Official Transcript of Proceedings

NUCLEAR REGULATORY COMMISSION

Title: Advisory Committee on Reactor Safeguards  
587th Meeting

Date: Thursday, October 6, 2011

# Diagram of Current FCOP

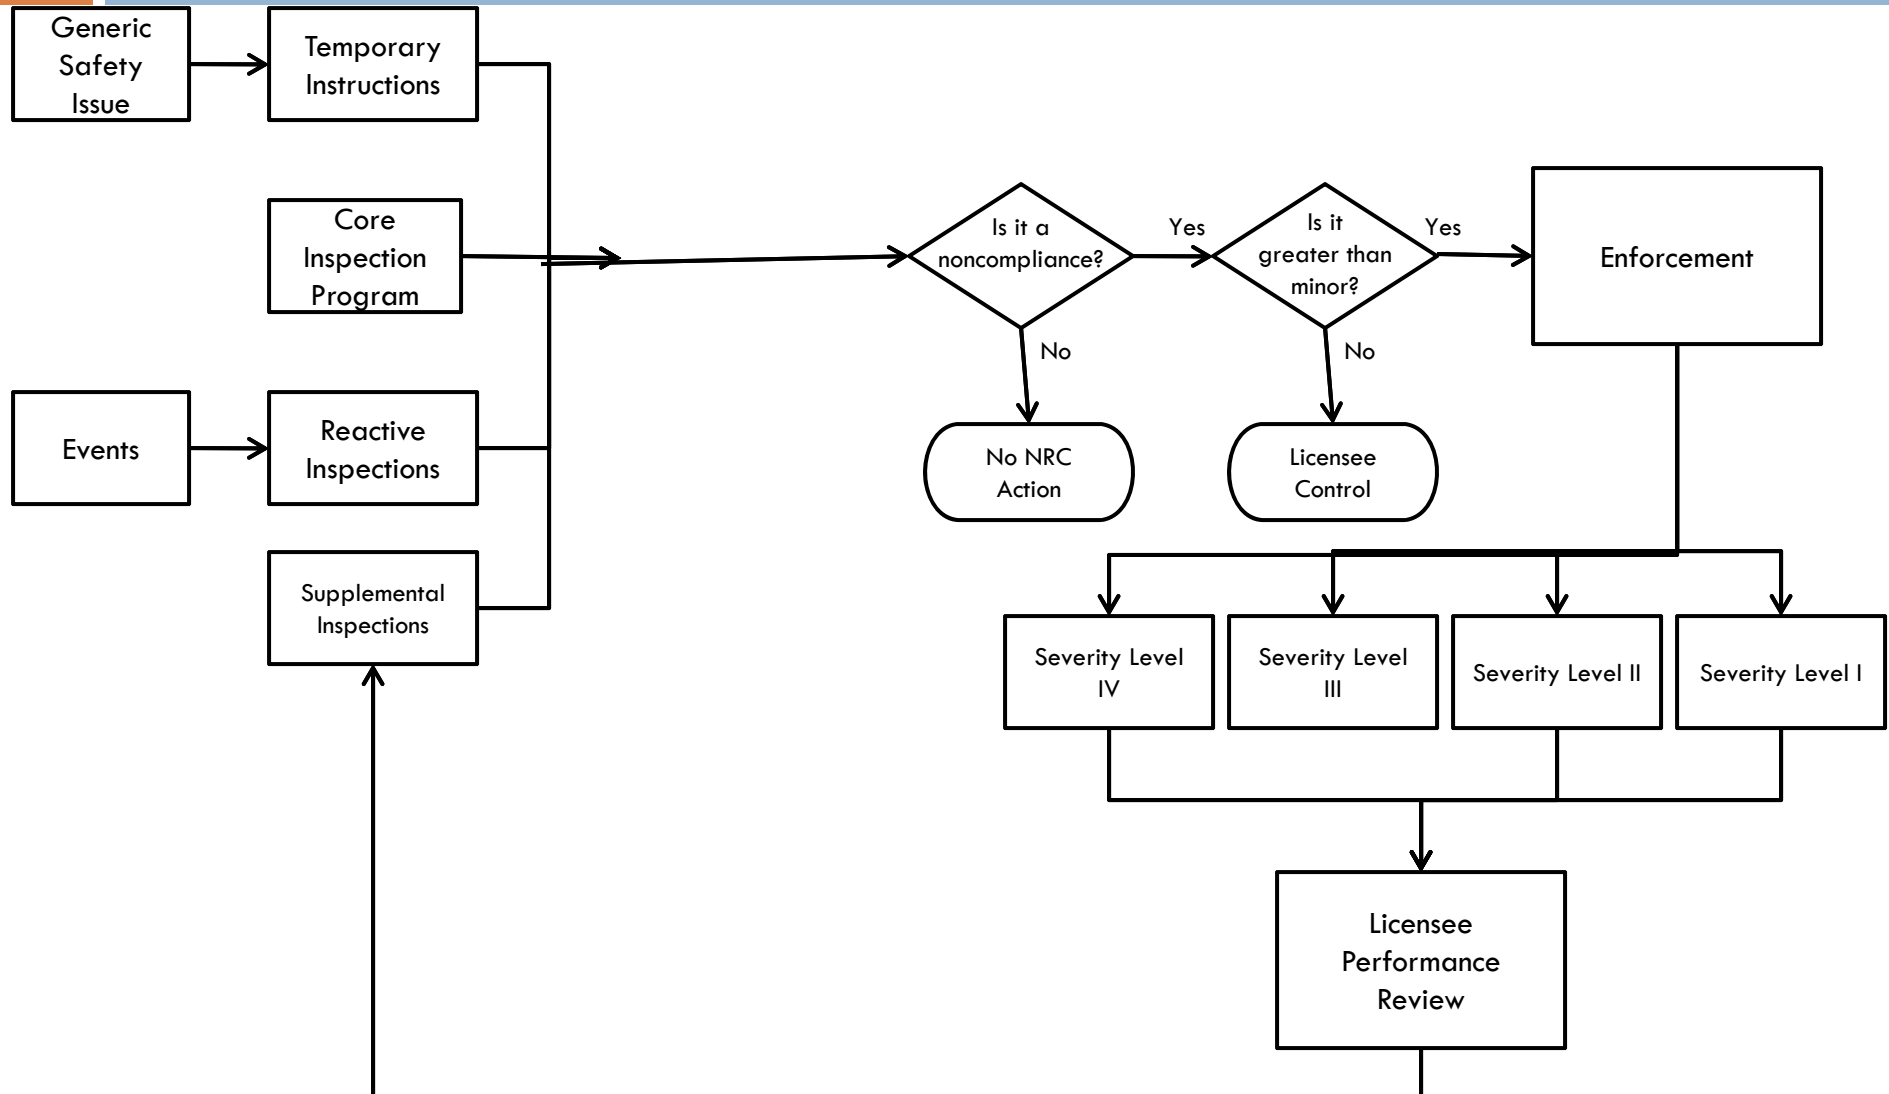
22 MEMBER SIEBER: I have a question about  
23 your chart. The bottom right-hand box, the bottom  
24 initialism is material control and accountability. Is  
25 that correct?

20 MEMBER SIEBER: Well, the only reason why  
21 I question that is I don't want there to be a loophole  
22 here because this has happened before.

# Conceptual Diagram of Enhanced FCOP

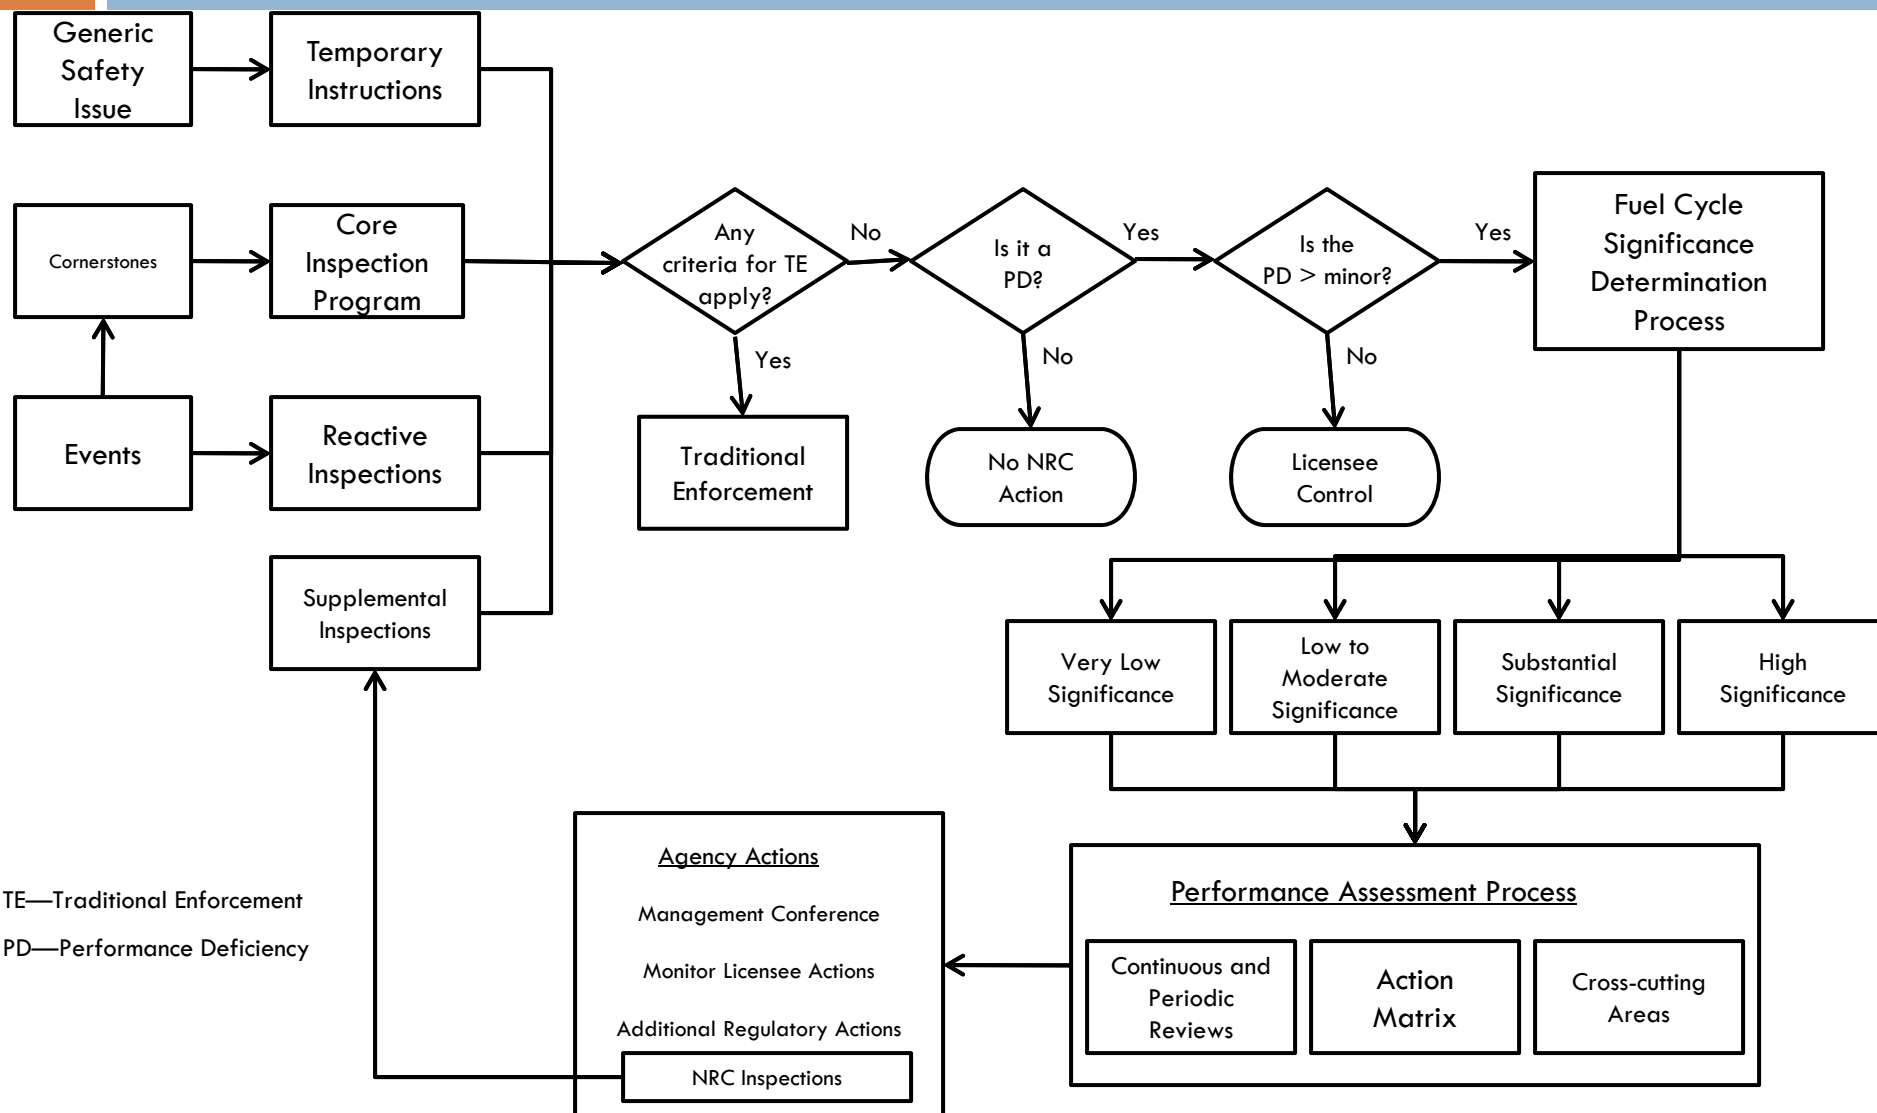
16                  MEMBER ARMIJO:   I thought the arrow should  
17                  point the other way. Cornerstones provide information  
18                  to help you assess what these events --

22 MEMBER SHACK: That was my question. It  
23 seems to me the traditional enforcement box is in the  
24 wrong place. I would have it somewhere after the  
25 significance determination. If it's very low
